Re: Geotechnical Consultation and
Response to County of San Mateo
Geotechnical Comment
Highlands Estates (Lots 9 and 10)
San Mateo, California

Response to Comment October 30, 2018 for Lot 9 and 10

Subject: **Highland Estates Lots 5-11 Response to County Comments**

HIGHLAND ESTATES
LOT 9 IMPROVEMENT PLANS
GEOTECHNICAL MITIGATION PLAN (LOTS 9 AND 10)
CITY OF SAN MATEO SAN MATEO COUNTY CALIFORNIA

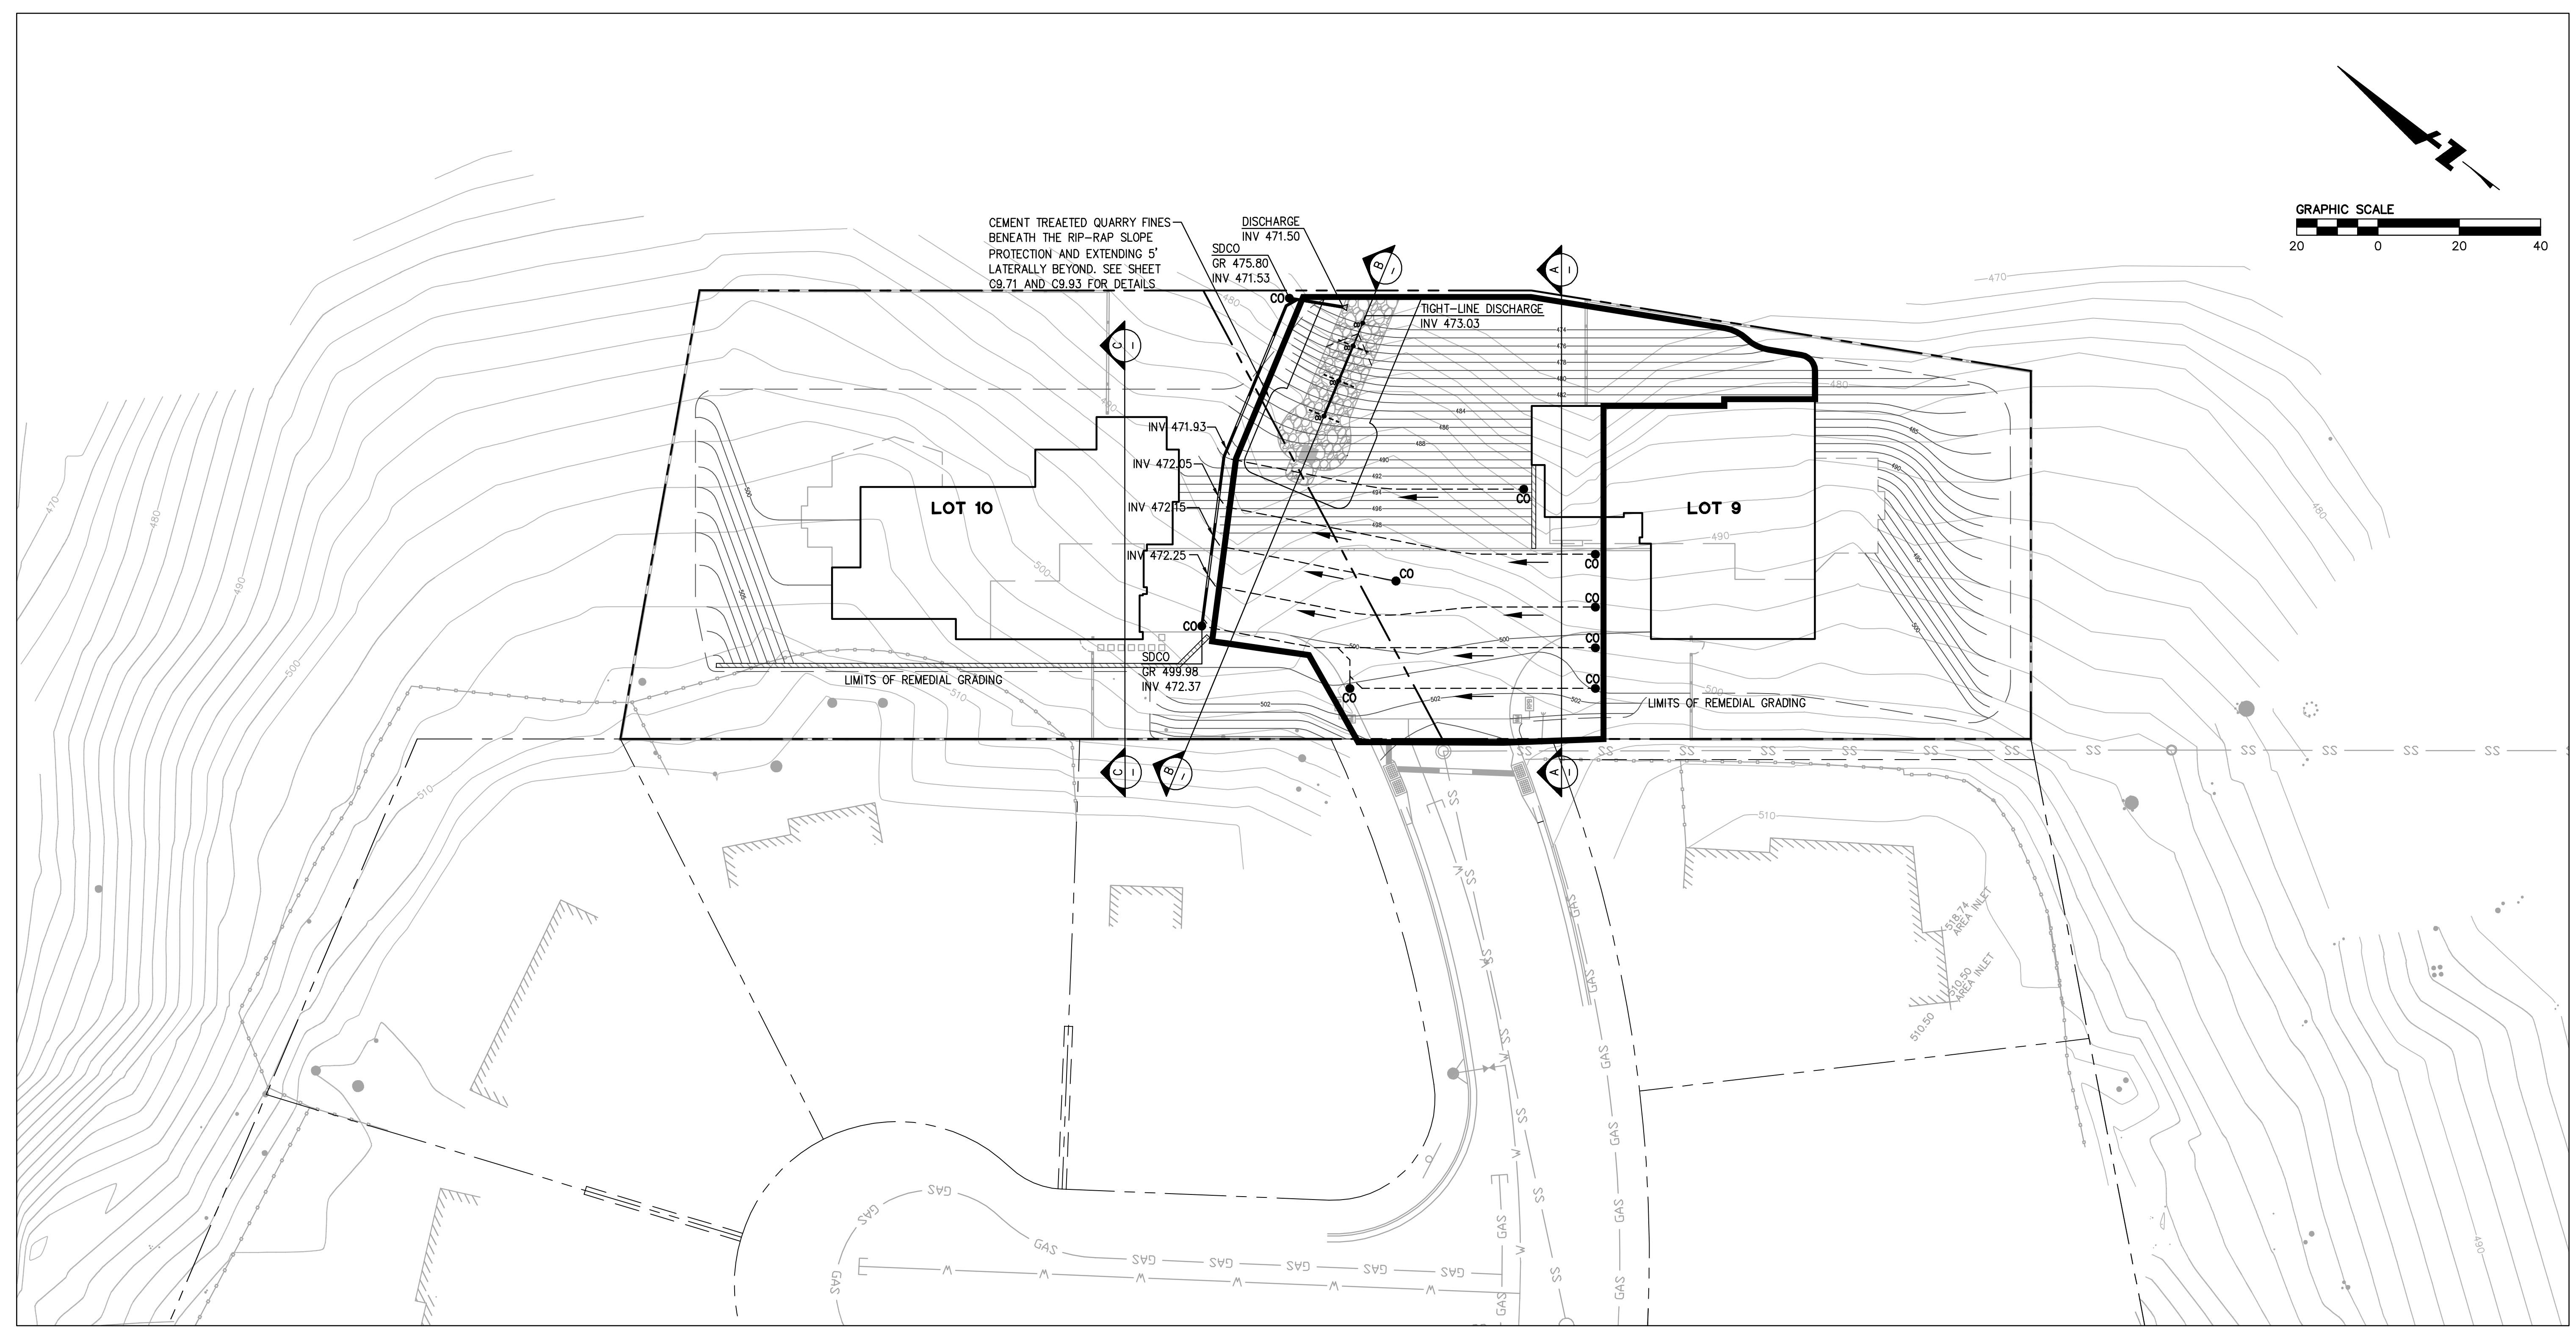
Comment #1: *As the slope below the riprap is 2:1 as shown on BKF Sheet C9.71 for Lot 9 (dated 10-8-18), if water must be discharged across the face of a steep fill slope, then County requires the implementation of one of the following measures:*

1. *Construction of a type of impermeable barrier utilized to isolate the surface waters from the fill material. NOTES: This measure will need to be shown on the civil plans and require another round of revision and review. If earth materials for fill construction are of a type that creep at a 2:1 slope, then a hard grouted rock channel may not be a good solution.*

As we discussed, the project owner would like to implement the first option to address the above comments. As shown on Sheets C9.71 and C9.93 of the project Civil Plans, the rip rap slope protection will be underlain Marifi FW 700 geotextile fabric or approved equal. We do not recommend the rip rap be hard grouted because that will reduce rock's function of dissipating energy and slowing down the water after being discharged into the rock lined channel. As an alternative to grouting the rock to create an impermeable barrier to isolate the surface water from the underlying fill material, we recommend placing a select fill material consisting of quarry fines mixed with cement beneath the rip rap and geotextile fabric. We have made revisions to Sheets C9.71, C9.91 and C9.93 (see attached) showing the thickness and lateral extent of the select fill material beneath the rock lined channel. We recommend that the Quarry Fines from Stevens Creek Quarry be mixed with bulk cement on-site, moisture conditioned and compacted as recommended in our report. We recommend about 3 percent cement (i.e. 4 pounds of cement per cubic foot of Quarry Fines, compacted in-place). The spreading of the cement would likely need to be done by hand at the job site prior to the placement in the fill. Our representative should be on-site during placement to verify the percentage of cement being used in the fill as well as monitoring mixing of the cement, moisture conditioning, and compaction. The material should be compacted within 2 to 4 hours of the initial mixing of the cement. The cement treated select fill material would not be subject to soil creep.

Sheet Number:
C9.91
OF

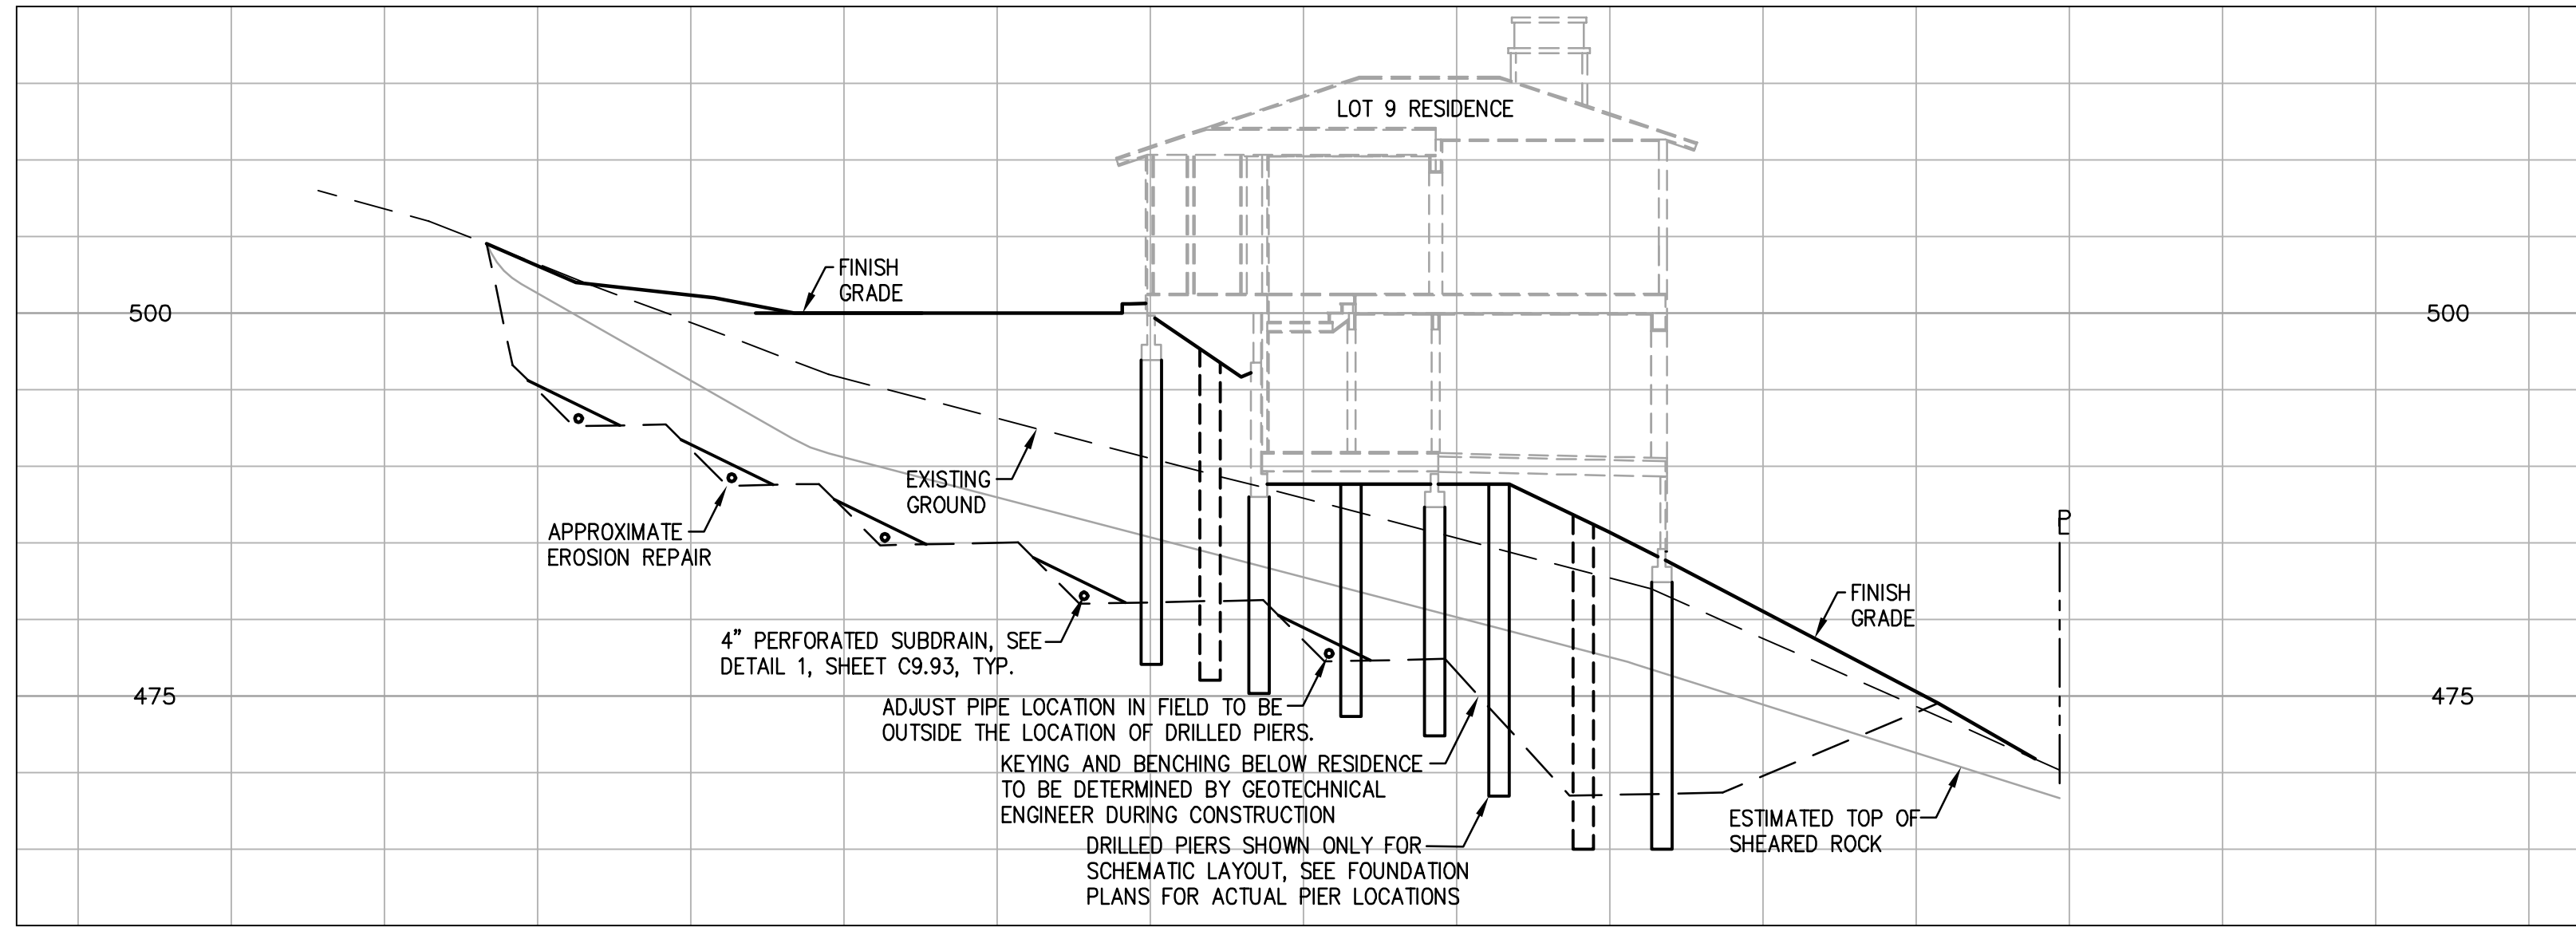
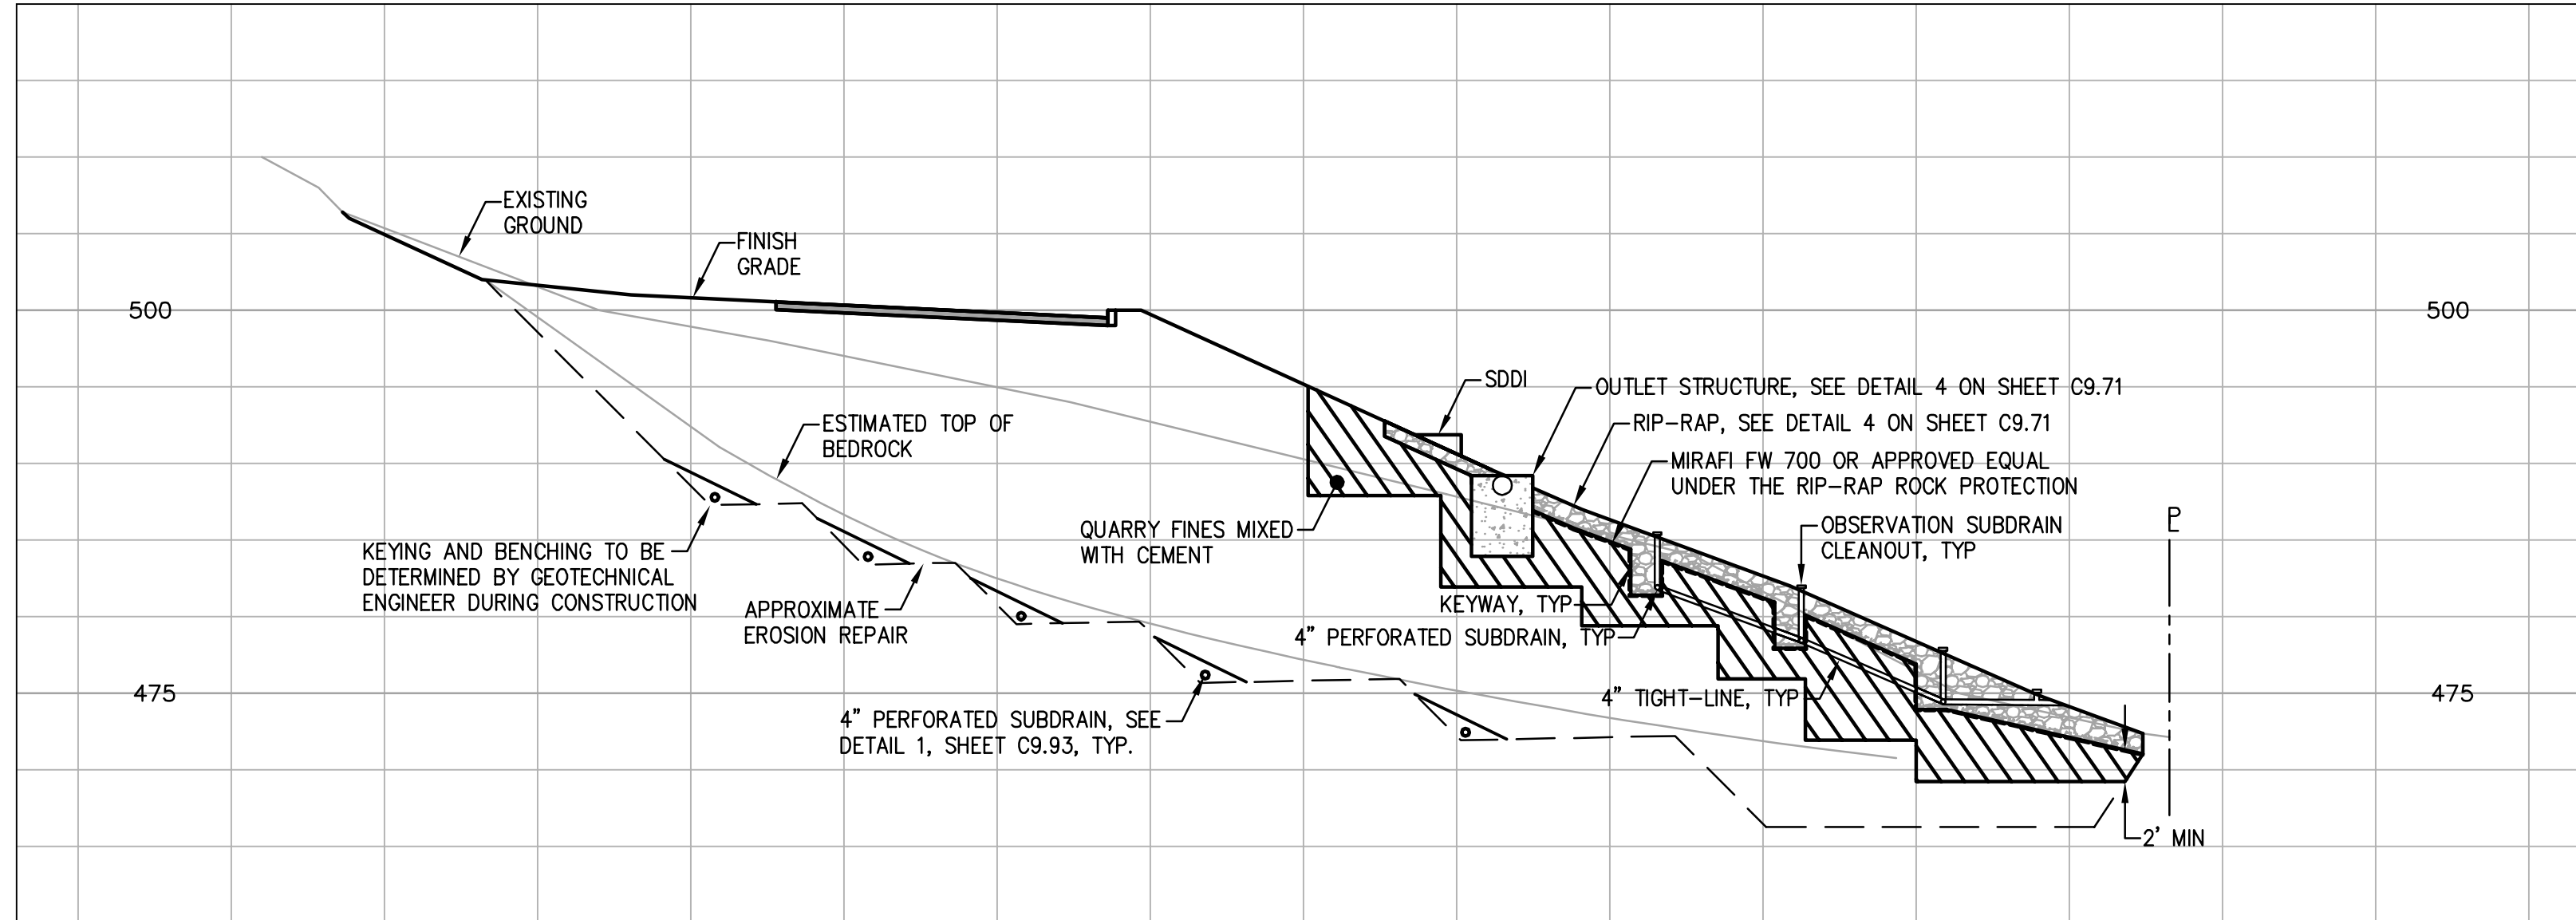
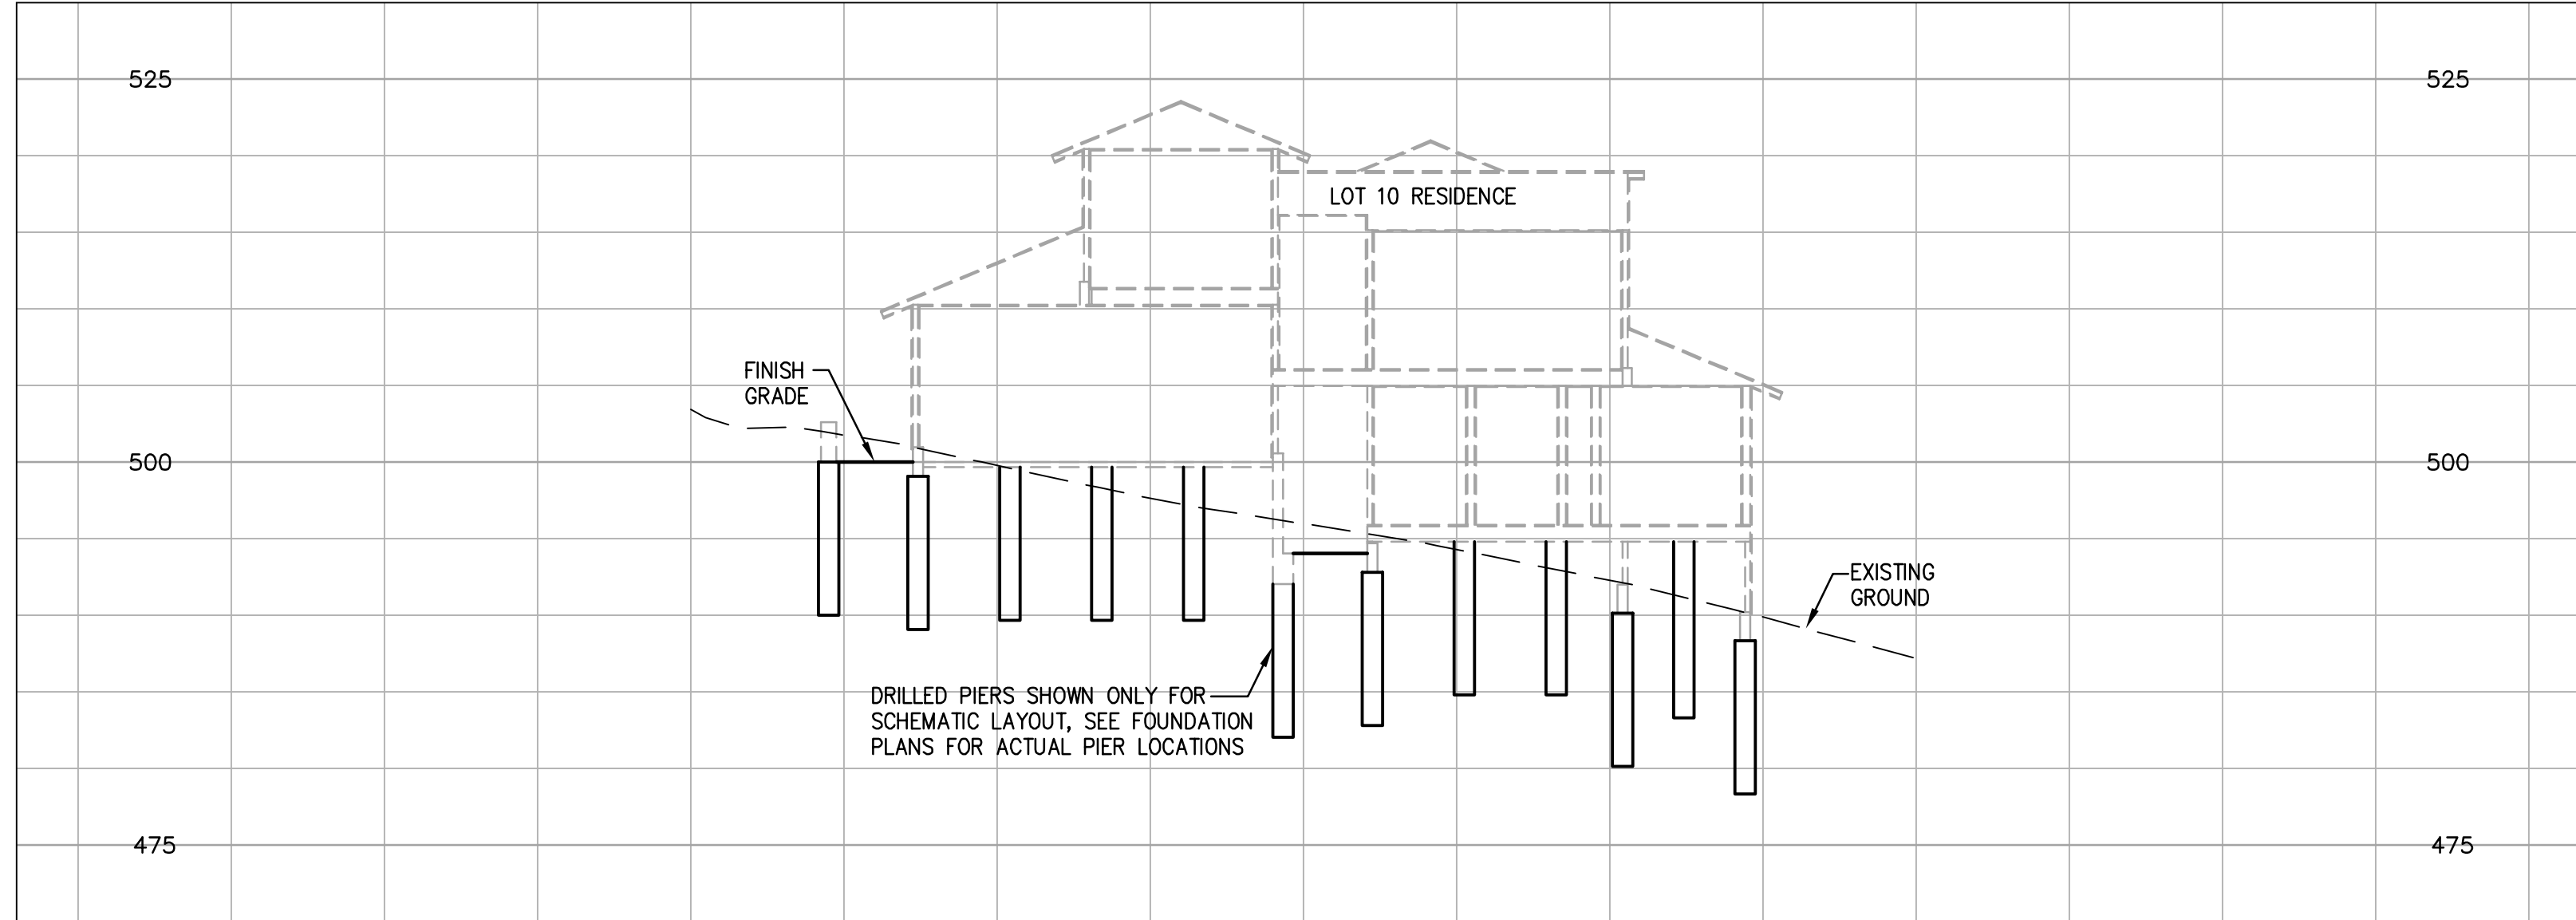
Comment #5: LOT 8-11 - 5. The Civil plans must show the extent of earth work required to ensure the stability of all affected areas, as discussed by Sherry and Scott F. during that last round of comments. To this end, a simplified geologic plan overlaid on the proposed site plan, showing all areas where fill may need to be removed, must be provided.

Response: Please see sheets C5.91, C5.92, C6.91, C6.92, C7.91, C7.92, C8.91 and C8.92 for site plan extents of earthwork required as part of the slope mitigation on Lots 5-8. See sheets C9.91, C9.92, C9.93, C10.91, C10.92, C10.93, and C11.91 for site plan extents of earthwork required as part of the slope mitigation on Lots 9-11.
